REMARKS/ARGUMENTS

Annotated Sheet Showing Changes

Fig.1
Prior Art

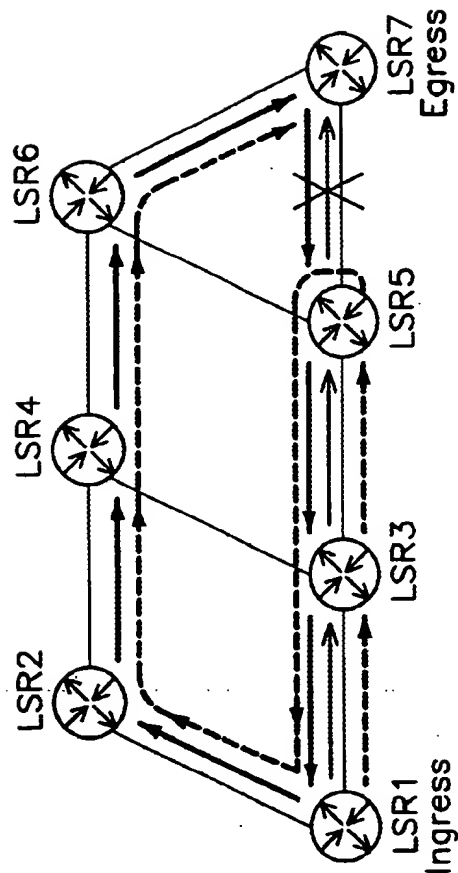
In the Office Action, the drawings are objected to as containing informalities. In particular, Figures 1 and 2 are objected to as lacking legends identifying them as prior art, and Figure 3 is objected to as including the legend "Reverss".

Figures 1 and 2 are amended herein to include legends identifying them as prior art.

Applicants respectfully traverse the rejection. Figures 1 and 2 are amended herein to include legends identifying them as prior art. Figure 3 is amended herein to replace "Reverss" with "Reverse".
